SUBJECT: CERTIFICATION OF THE MINUTES OF THE ACRS REGULATORY
POLICIES AND PRACTICES SUBCOMMITTEE ON MAY 19, 2016

ADVISORY COMMITTEE ON REACTOR SAFEGUARDS
MINUTES OF THE ACRS REGULATORY POLICIES AND PRACTICES SUBCOMMITTEE
MEETING ON May 19, 2016

**State-of-the-Art Reactor Consequence
Analyses (SOARCA) Project:
Sequoyah Integrated Deterministic
and Uncertainty Analyses**

Figure 3-14: Possible transitions in the 3-SV pressurizer pressure relief system considering both FTO and FTC valve conditions

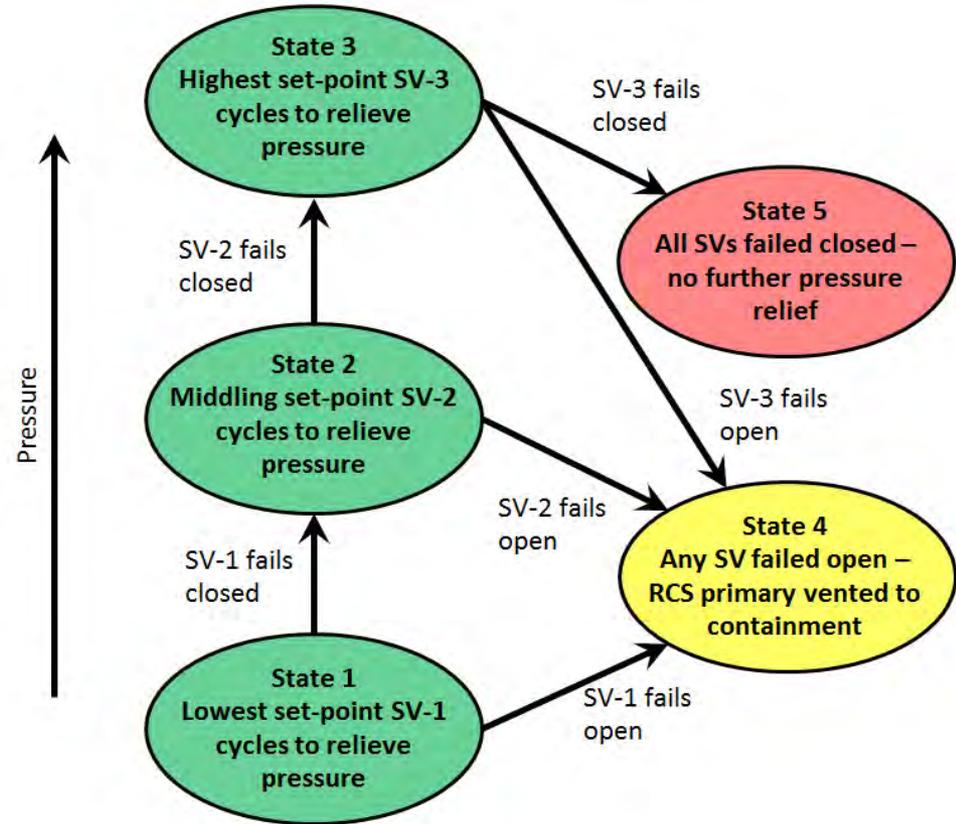
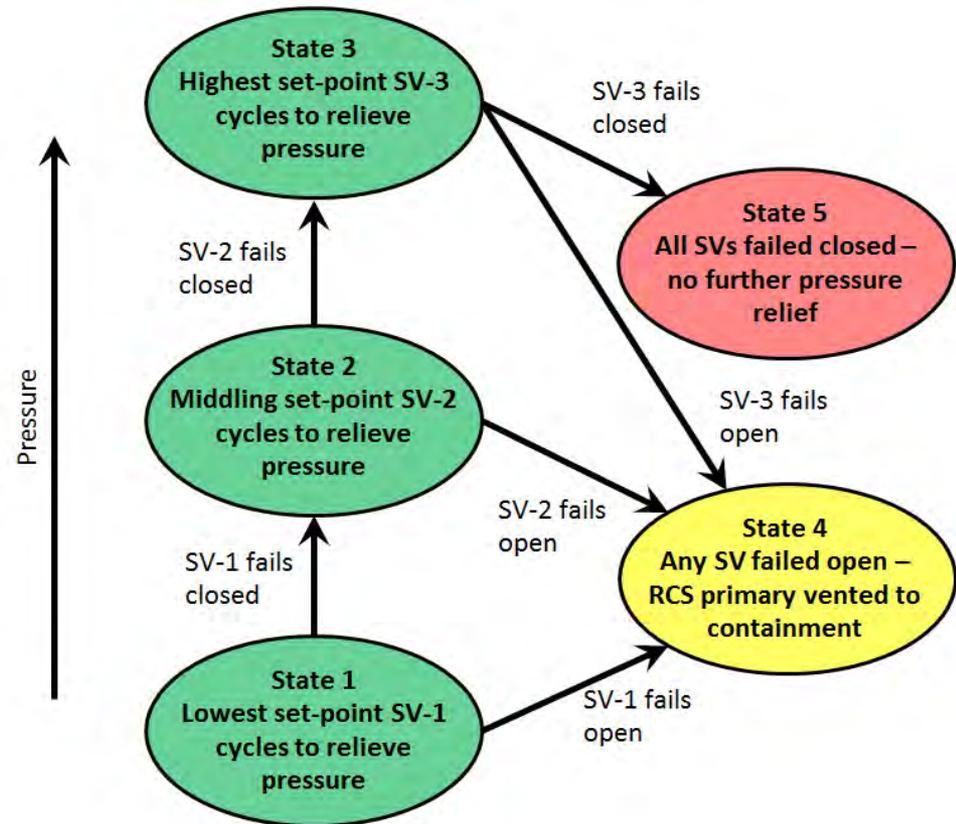
18. Chairman Stetkar questioned the way the pressurizer safety valves are modeled in MELCOR. Chairman Stetkar referred to Table 4-14 in the	70-74

7 This diagram that you have here, as I
8 understand it these valves are modeled in MELCOR as
9 if they are completely independent. Is that
10 correct?
